UNITED STATES PATENT AND TRADEMARK OFFICE

Office Action Summary	Application No. 10/502,104	Applicant(s) SHEMESH ET AL.	
	Examiner PHILLIP A. JOHNSTON	Art Unit 2881

Detailed Action

Claims Rejection – 35 U.S.C. 103

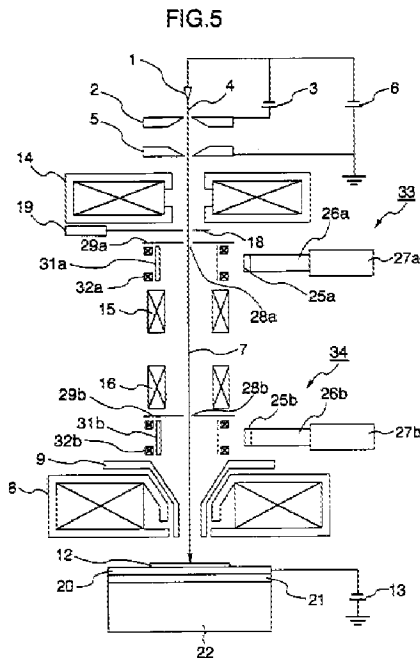
5. Regarding claim 13, Todokoro discloses an apparatus in Figure 5 below having;

(a) a primary electron beam 7 and a column through which the beam propagates to sample 12. See Col. 5, line 15-26,

(b) upper and lower deflectors 15 and 16, located upstream and downstream of interior (in-lens) detectors 33 and 34 respectively. Col. 8, line 22-34. Deflectors 15 and 16 are scanning deflectors, which one of ordinary skill would recognize are deflectors that deflect the primary beam across the sample 12 in a series of parallel axial (spaced apart) trajectories. See Col. 5, line 45-53.

(c) sample 12 is located in the gap of the objective lens 8, where a high (substantial) electric field is introduced. Col. 8, line 15-21,

(d) impinging the primary beam on sample 12 to generate secondary electrons, that include reflected and scattered which are extracted into an aperture of the objective lens by the electric field applied across the objective lens and the sample where they are directed up through acceleration tube 9 towards one of the interior detectors. Col. 2, line 20-25; and Col. 5, line 15-26.

FIG.2

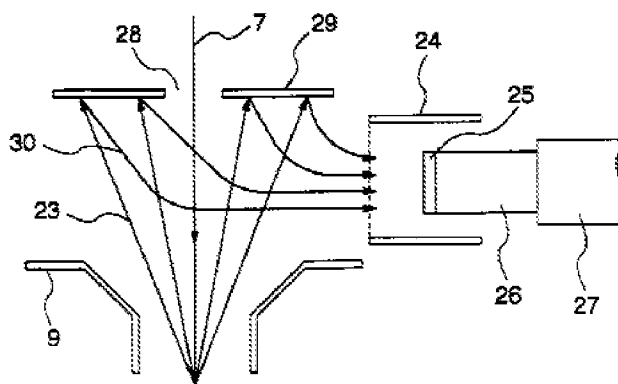
Regarding the wherein limitation, Todokoro discloses generating secondary electrons from sample 12 having initial trajectories in various directions, as shown in Figure 2 below. See Col. 6, line 40-67.

However, Todokoro fails to teach the trajectory of at least some of the electrons is substantially coincident with one of the first and second optical axis.

It would have been obvious to one of ordinary skill that the trajectories of secondary electrons resulting from impinging the primary beam 7 are reflected or scattered at many varying angles some of which are shown in Figure 2 below.

Therefore it would have been obvious to one of ordinary skill in the art at the time the invention was made that impinging the primary beam on a sample in accordance with Todokoro would provide at least some of the electrons generated with trajectories that are substantially coincident with the optical axis of the primary beam.

FIG. 14B

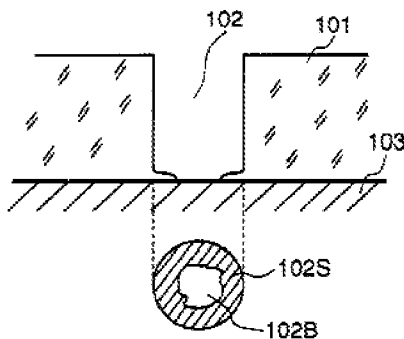
13. Todokoro (238) fails to disclose processing the received detection signals to provide an indication about a defect or a process variation; and wherein detected electrons include electrons from a lower portion of a high aspect ratio hole.

14. Todokoro (873) teaches observing residue at the bottom of a high aspect ratio contact hole. See Figure 14b below; Col. 2, line 8-18; and Col. 5, line 39-49.

15. Todokoro (873) modifies Todokoro (238) to provide a technique for displaying the condition of a contact hole formed in an insulator on the display screen of a scanning electron microscope.

16. Therefore it would have been obvious to one of ordinary skill in the art that Todokoro (238) would use the contact hole imaging technique of Todokoro (873) to provide a scanning electron microscope for observing the bottom of a contact hole formed on an observation sample such as an IC.
